City of El Paso – City Plan Commission Staff Report

(REVISED)

Case No: SUSU14-00062 Que Padre Subdivision
Application Type: Major Combination
CPC Hearing Date: August 18, 2014
Staff Planner: Nelson Ortiz, (915) 212-1606, ortiznx@elpasotexas.gov
Location: East of Sunland Park and South of Doniphan
Acreage: 9.115 acres
Rep District: 8
Existing Use: Vacant
Existing Zoning: C-3/c (Commercial/ condition)
Proposed Zoning: C-3/c (Commercial/ condition)
Nearest Park: Riverbend linear park (.18 mi.)
Nearest School: Zach White Elementary School (1.12 mi.)
Park Fees Required: \$9,120.00
Impact Fee Area: N/A
Property Owner: EP Sunland, LLC.
Applicant: EP Sunland, LLC.
Representative: Kimley-Horn and Associates

ATTACHMENT 3

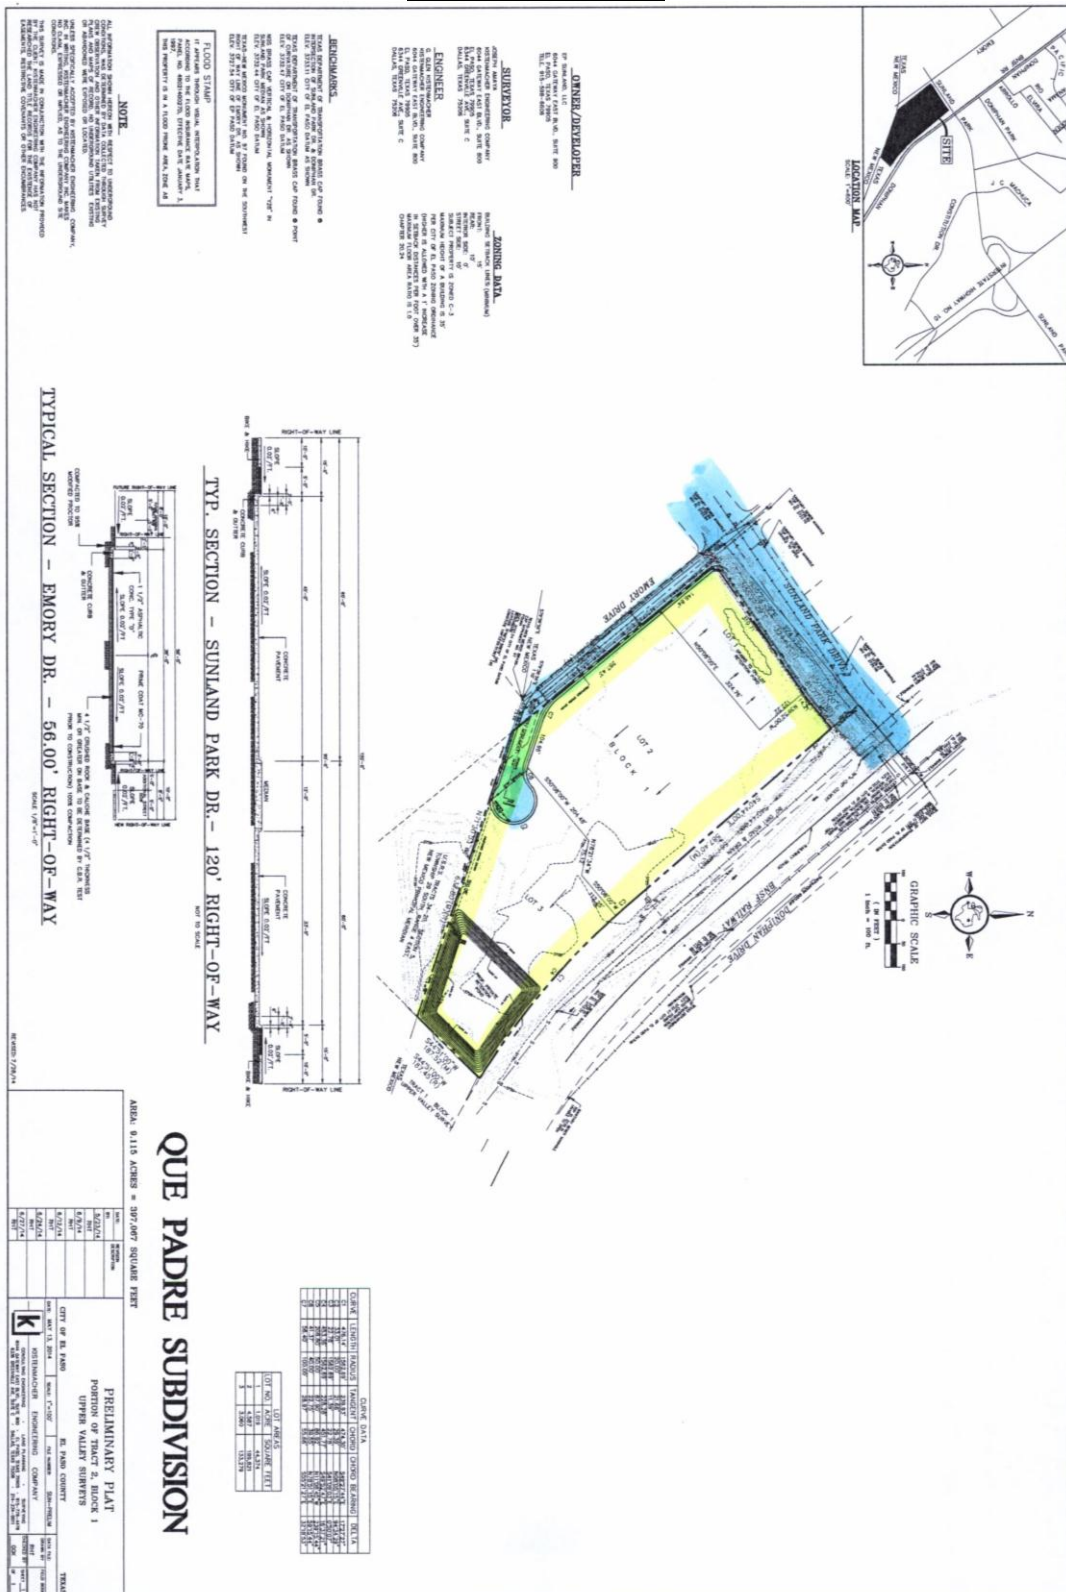
1. Any development within Special Flood Hazard Areas must comply with Section 18.60- Flood Damage Prevention and FEMA flood zone requirements.
2. The Storm-water Master Plan recommends enlarging existing culvert across Sunland Park Dr. and expanding the existing channel; no storm water run-off is allowed into the channel.

3. Delineate the subdivision boundary limits clearly with a double dashed bold line. Provide the subdivision boundary closure report.
4. Provide an inspection and maintenance agreement for private storm-water facilities in accordance with Section 19.19.040.

5. Provide street cross-sections of Emory Dr. and Sunland Park Dr., label slope and direction. Pavement values shall be as per CBR results on typical street cross sections. Large truck loads and high traffic volumes are expected.

6. Provide drainage easements for storm sewer systems flowing through lot three into private pond area and show on the final plat.
7. Storm-sewer system should be added on dedication statement on final plat for portions of storm-sewer system within public R.O.W.

8. Show proposed street monuments on final plat.
